REVIEW

RE: 300 Allen Avenue, Portland, Maine
Letter of Correspondence #5

Comments by Kandice Talbot/City of Portland Dated 09/23/03

Drawing Name: **Grading, Drainage & Erosion Control Plan**
 Project: **300 ALLEN AVE.**
 Client: **Bob Adam**
 662 East Bridge Street, Westbrook, ME 04092

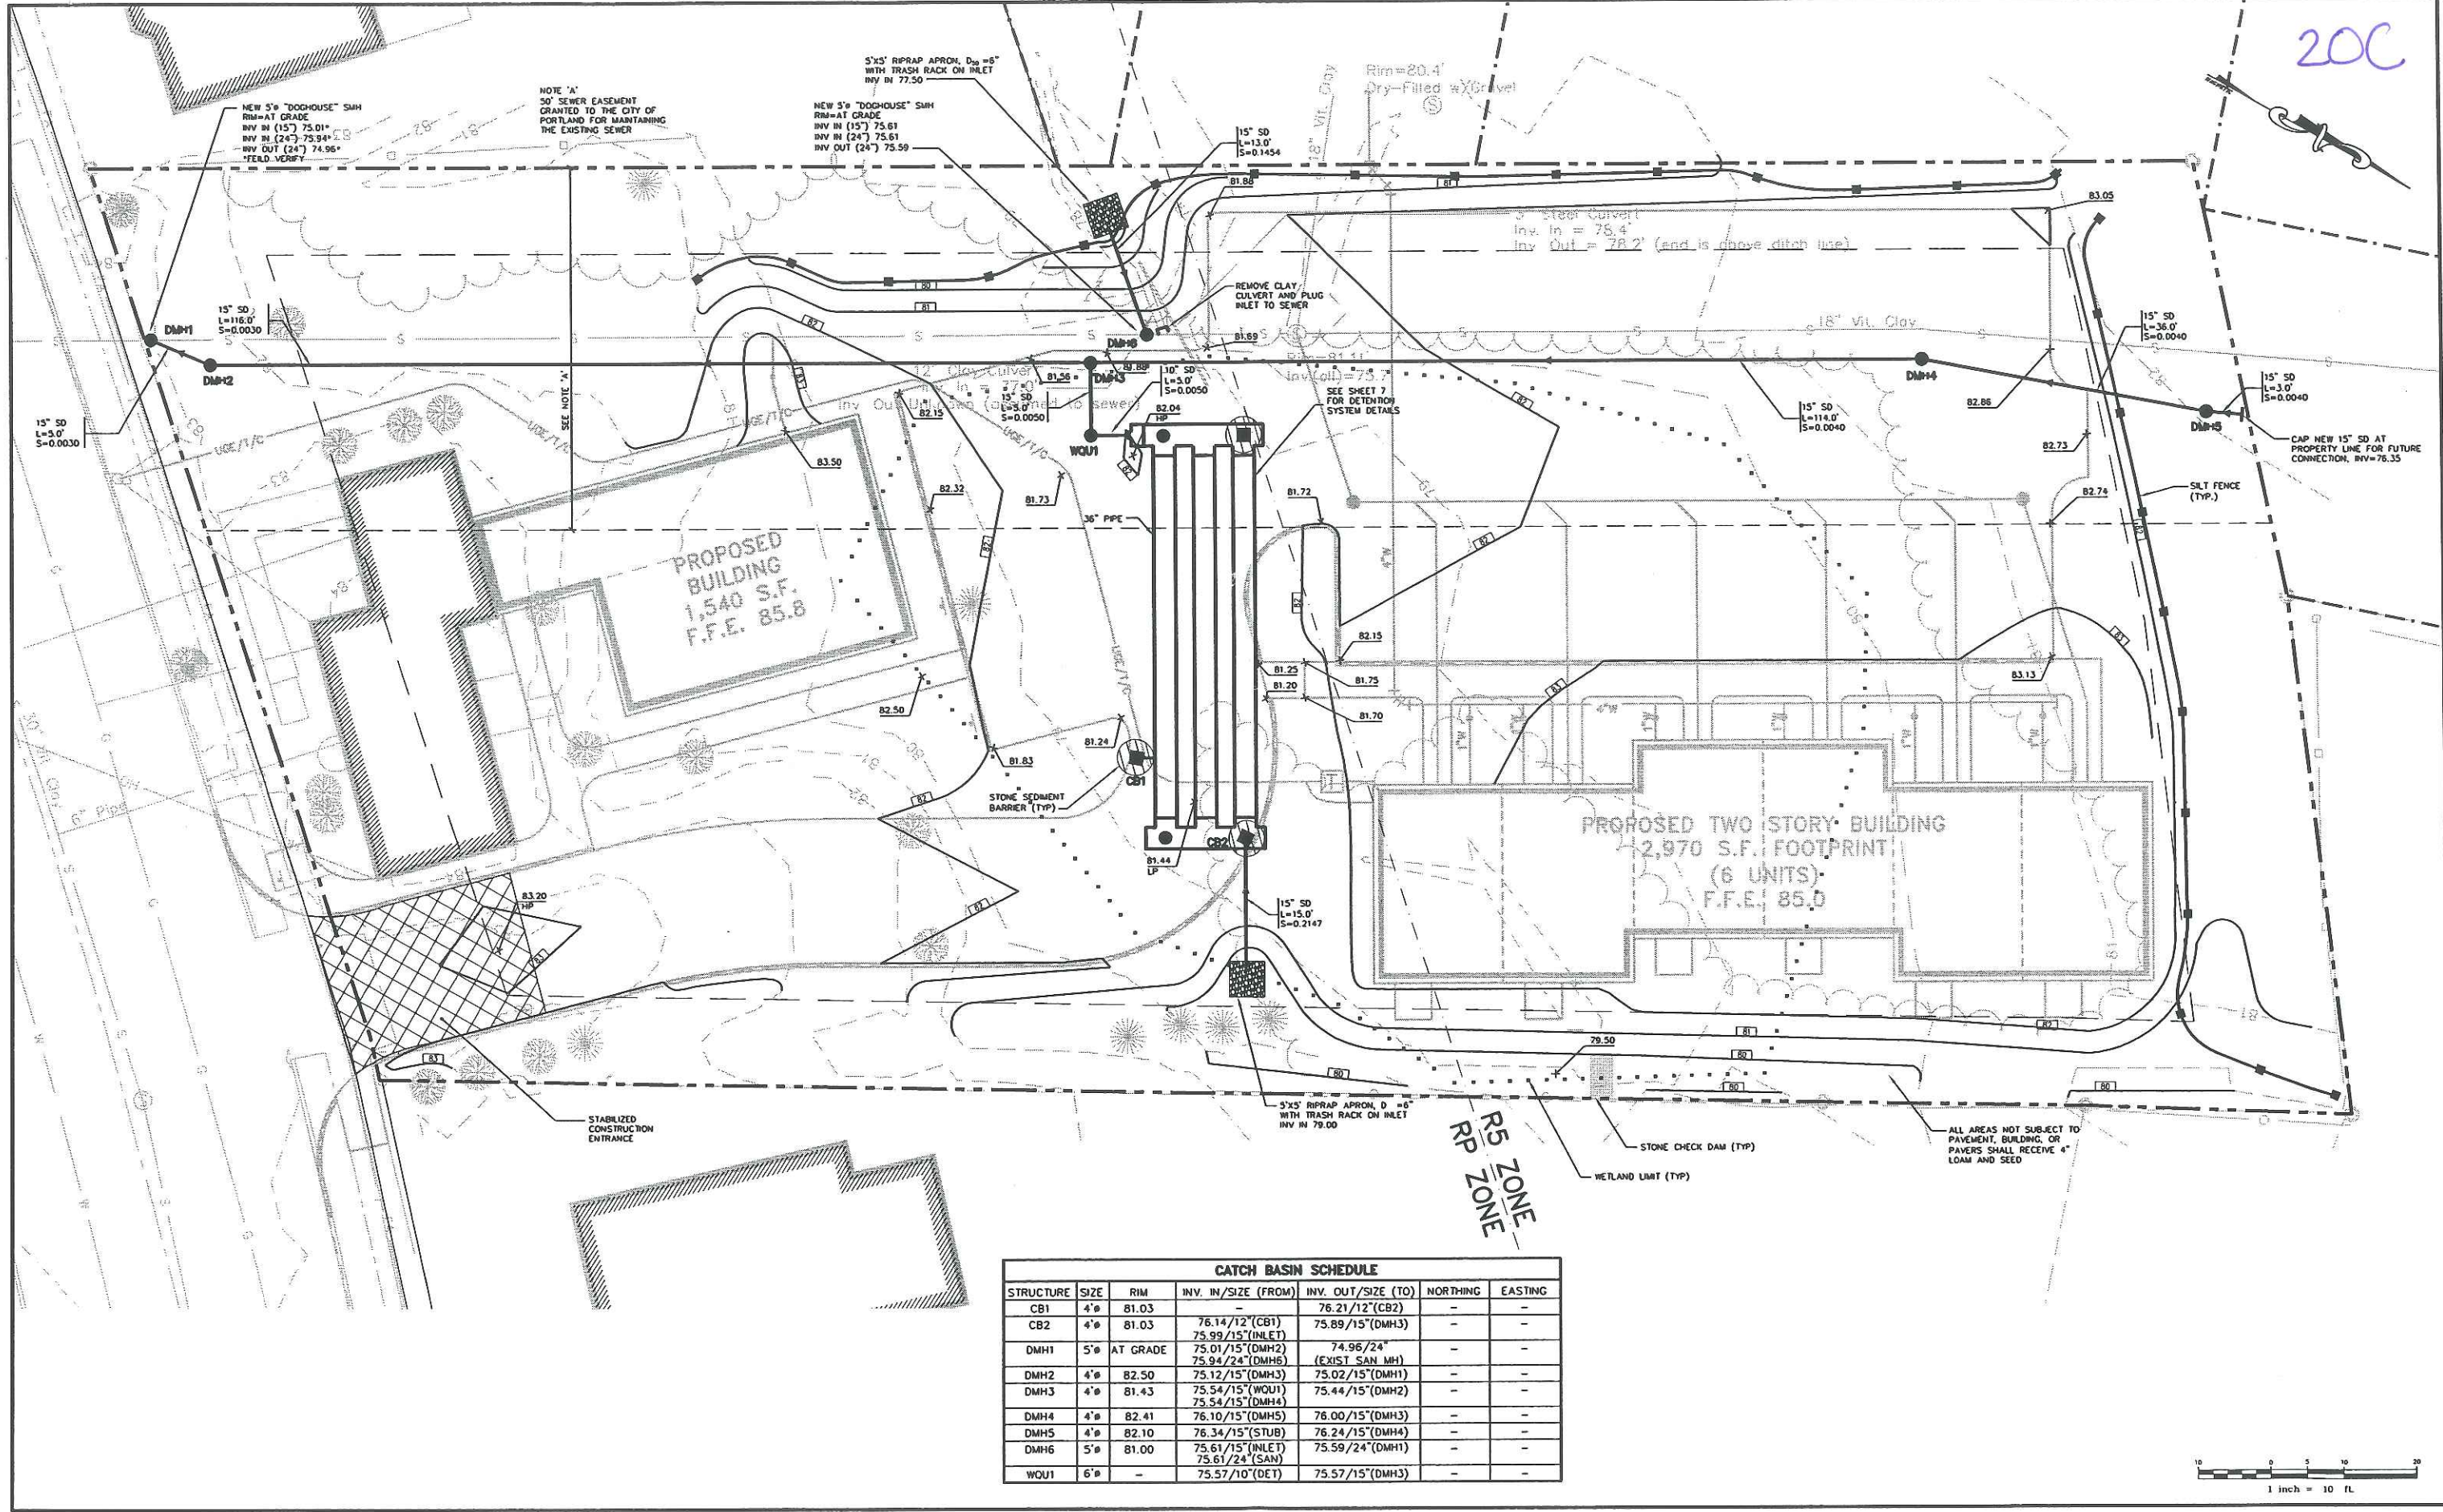
Comment 6 – General erosion control notes and measures will need to be shown for the proposed project.

Response – Erosion control measures have been added to the grading plan. Erosion control notes have been included within the detail sheets.

DETENTION POND PLAN
1"=5'

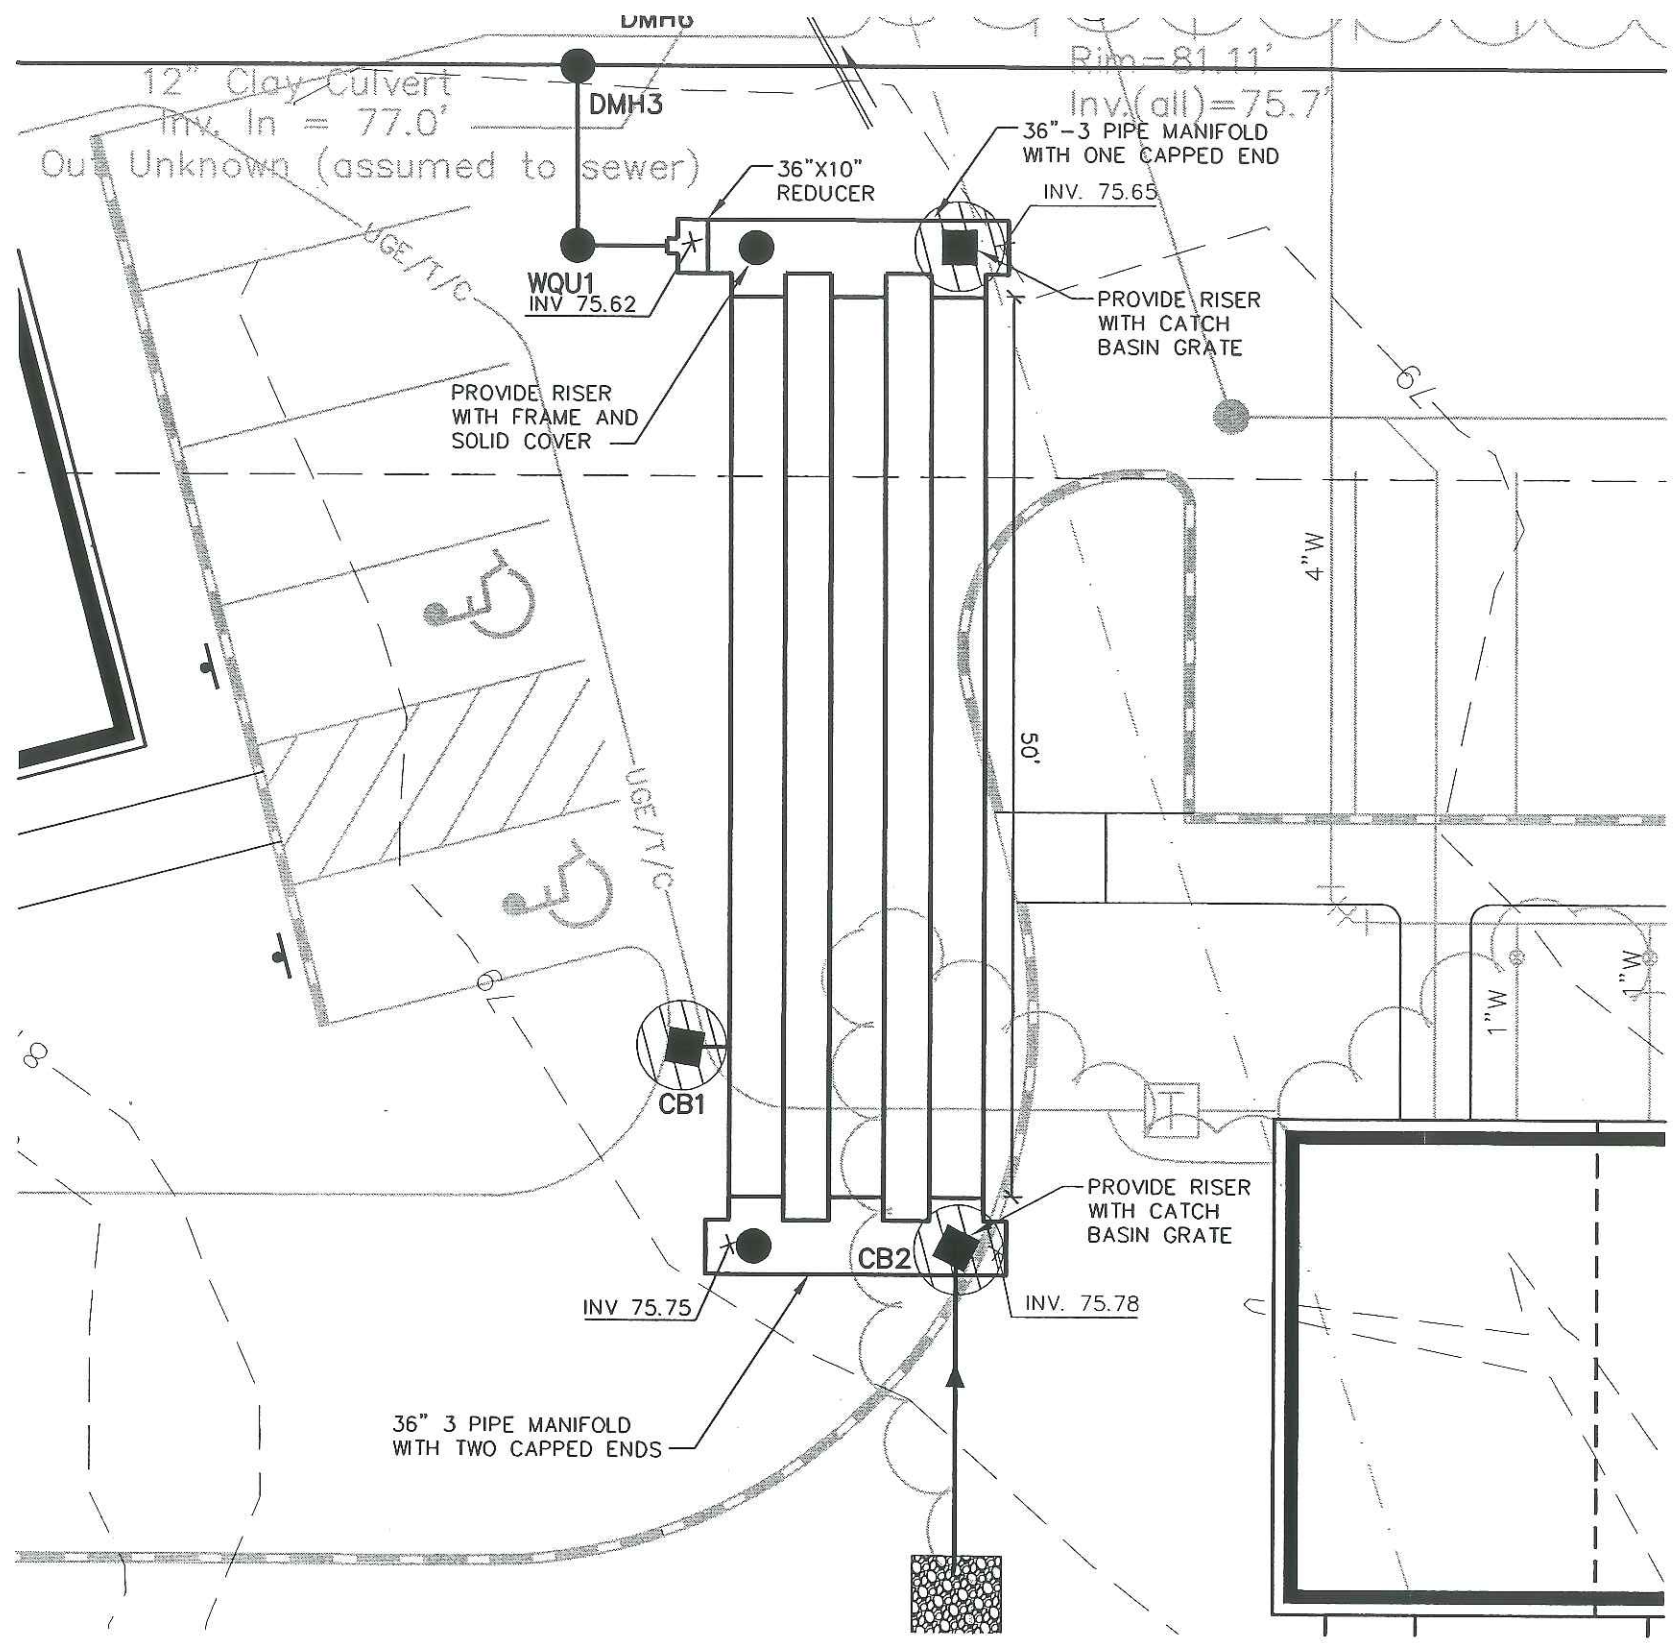
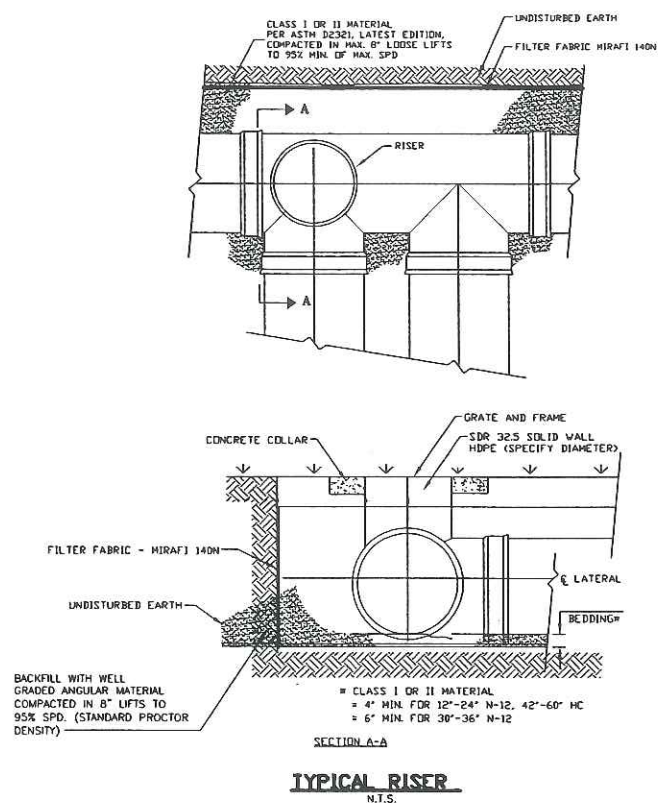
Comment 1 – I have read the letter from Alton Palmer, P.E. of Gorrill-Palmer Consulting Engineers, Inc. and agree that the stormwater detention issue for this proposed project will be the same as the previous approved project on the same site. However, I still have concerns about the quantity of stormwater that could be introduced into the combined sewer system until the drainage separation project in Allen Avenue occurs. Looking at the previous calculations and considering that there is more impervious surface, we believe that every effort shall be done to minimize the amount of flow above the allowed peak rate of runoff. We feel that the applicant can further add a design that can limit the peak amount of runoff into the combined system by possibly utilizing either underground storage or using oversized pipes, and using flow controls such as hydro-brakes to allow temporary ponding in proposed catch basins, pipes, and low lying areas. At a minimum, the applicant shall receive a letter from the Public Works Department allowing the designed peak flow into the combined sewer. The applicant also needs to include the actual calculations and summary for the required design storms and its effects on site and downstream.

Response – The Stormwater analysis included with this package provides calculations in support of the proposed underground detention systems. Construction of the detention system prior to connection into the separated system allows for maintenance of predevelopment peak flows for the 2, 10 and 25-year storms. It is noted that Stormwater Analysis from the previously approved submission was not used in Gorrill-Palmer Consulting Engineers, Inc.'s analysis. Offsite watersheds were redelineated and time of concentration paths were revised.
